# REVIEW OF COST CURVES

## A note prepared for Anglian Water

Anglian has produced cost curves for a number of measures ahead of PR19. It has commissioned Frontier to review its approach and to provide feedback. This note summarises our findings.

Figure 1 Forecast efficiency

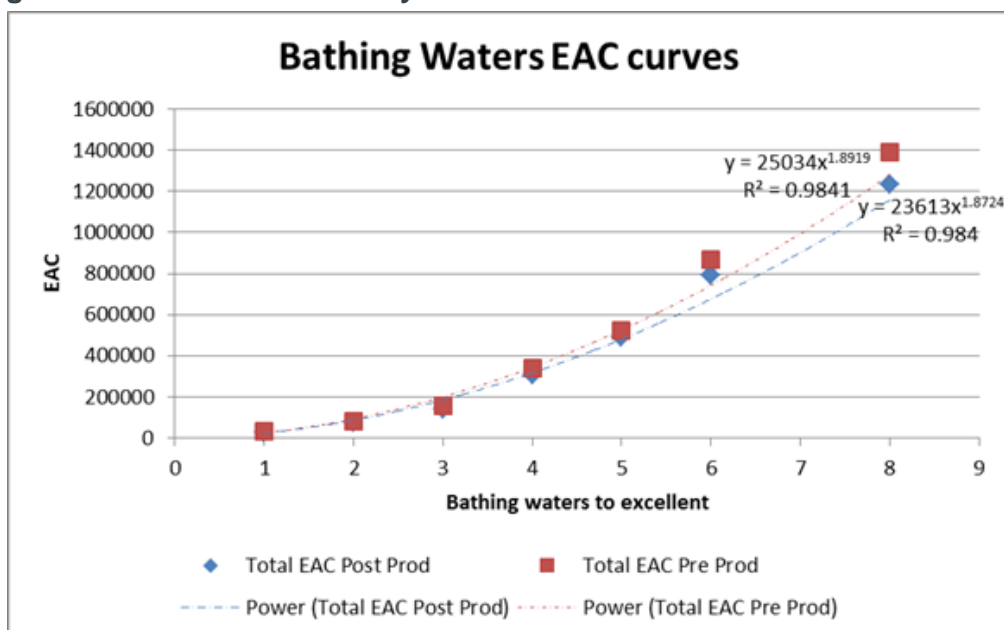
Anglian has produced its cost curves using its C55 investment optimisation model. Various candidate schemes, along with their associated costs and expected benefits, have been entered into the model and are all considered as part of the optimisation. However, initially the cost estimates were based on current cost levels, and not future cost levels. We recommended to Anglian that it introduce some element of forecast efficiency into its cost estimates.

Anglian has since applied a forecast productivity assumption to its input costs. It has reduced its cost estimates at a rate of 2.3% per annum. This is the same rate that it used in completing the PR19 business tables where forecasts needed to be made over a 40 year time horizon. A “before and after” example of its cost curve for bathing waters is shown below. This has had the effect of reducing its cost curve by nearly 6%.

We have not reviewed the details underlying the productivity assumption of 2.3% per annum, and have instead taken this figure as a given. However, by considering future cost levels rather than just current cost levels, we believe that Anglian's approach is more reasonable.

**Figure 2 Gaps in cost curves**

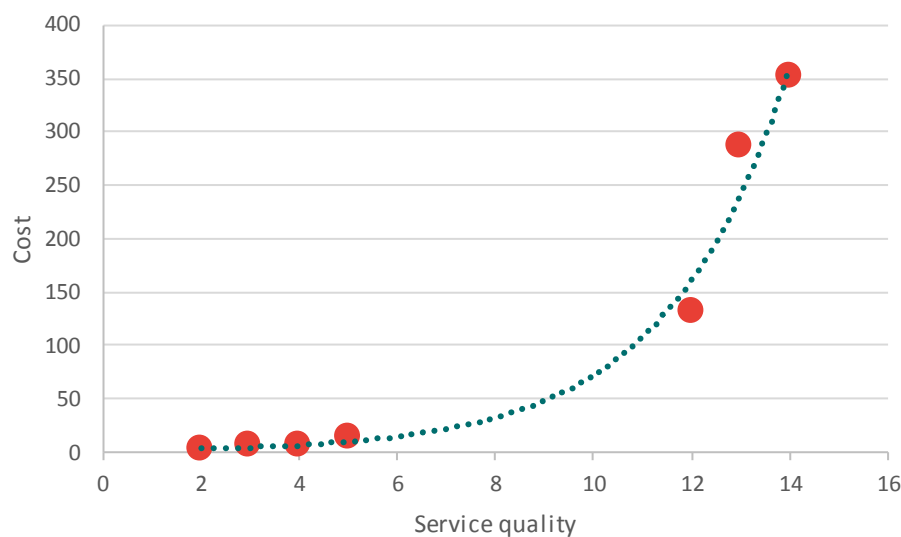
Anglian has used its investment optimisation model to estimate the cost of delivering different levels of service quality for different measures. For each measure, it has then fitted a line of best fit through these estimates to produce a cost curve. Some of the cost curves are based on relatively few data points, such that the distance between points (i.e. the difference in service quality) could be relatively large. For some measures, it is plausible that the PC lies within one of these 'gaps'. The estimate of the incremental cost of performing at the PC would therefore be heavily dependent on the assumed line of the best fit. This is illustrated below (using dummy data).

We recommended that if there are instances where Anglian's proposed PC does indeed lie within one of these 'gaps', it should sense check the estimate of incremental cost to ensure that it is indeed a robust estimate, rather than simply relying on an interpolation.

Anglian has taken on board this feedback. It has not changed its cost curves, but where these instances do arise, it has sense-checked the results to ensure that they are indeed reasonable. We believe this approach is reasonable.

**Figure 3 Trendlines**

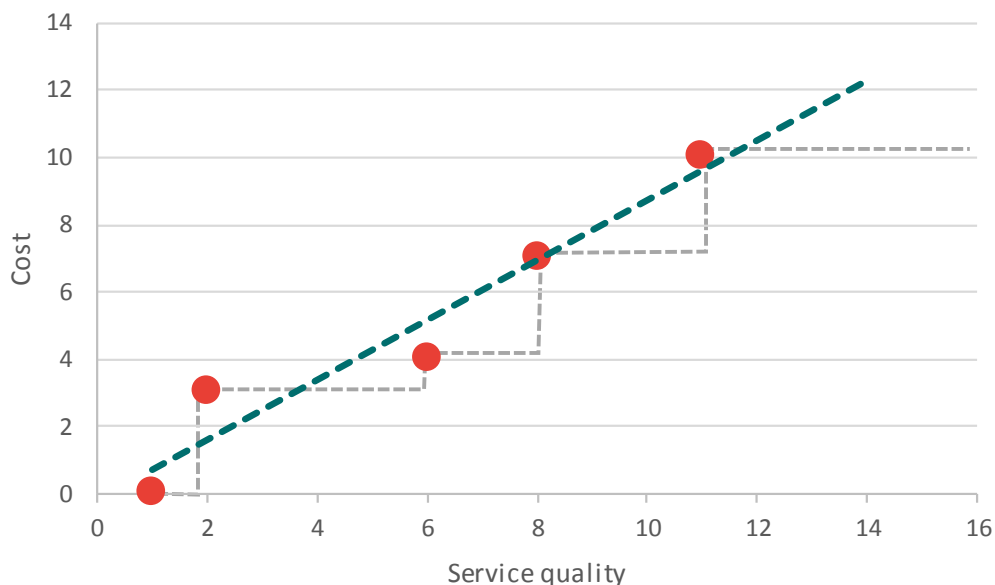
For some measures, especially those which involve lumpy investments, such as single supply and low pressure, the cost curve may not necessarily be perfectly continuous and 'curvy'. Instead, it may have a series of step changes. For measures of this kind, it may not be appropriate to fit a line of best fit through the data points, since it may not actually be possible to perform at a level in between the data points. For measures where this issue arises, we recommended that Anglian apply judgement in producing the cost curves, rather than necessarily having to rely on simple trendlines.
